SERVICE BULLETIN

APPLICABILITY: 2012-13MY Impreza 2.0L
 2013MY XV Crosstrek

NUMBER: 02-146-13

SUBJECT: Revised Valve Train Parts to Reduce a Warm Engine
 Tapping or Sewing Machine type Sound from the
 Left Cylinder Head

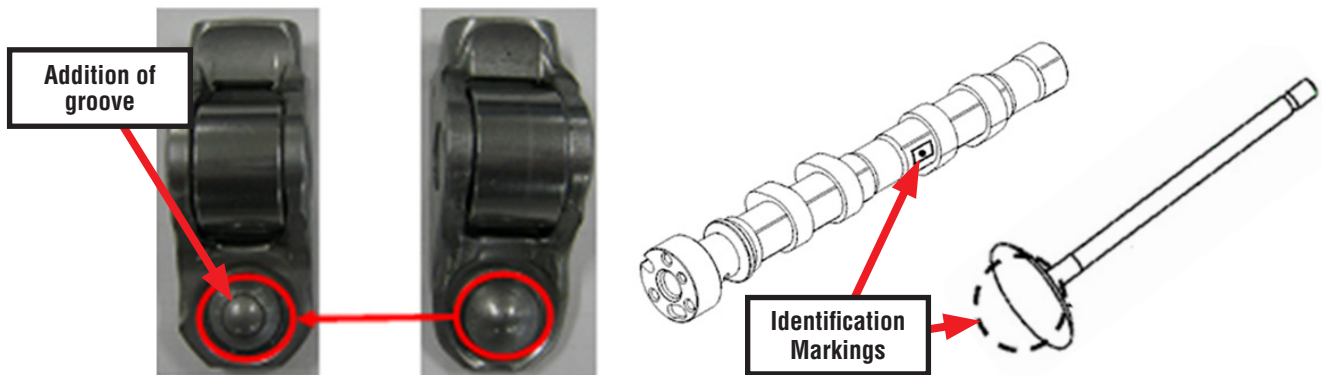
- Design change to the valve rockers
- Camshaft profile change
- Increased intake valve stem length (1.65mm longer Intake, 2.4mm longer Exhaust)

The illustrations below show additional information about the changes to the valve rockers, camshafts and valves to help readily distinguish them from the previous version parts.

PART NAME		NEW	OLD
INTAKE VALVE	Part Number	13201AA670	13201AA640
	Change	Valve stem length: 104.95mm	Valve stem length: 103.3mm
	Identification	I31	I22
EXHAUST VALVE	Part Number	13202AA750	13202AA670
	Change	Valve stem length: 96.5mm	Valve stem length: 94.1mm
	Identification	E3	E2
VALVE ROCKER	Part Number	13249AA250	13249AA240
	Change	Change to roller portion	-
	Identification	Circular groove added on pivot side	No groove
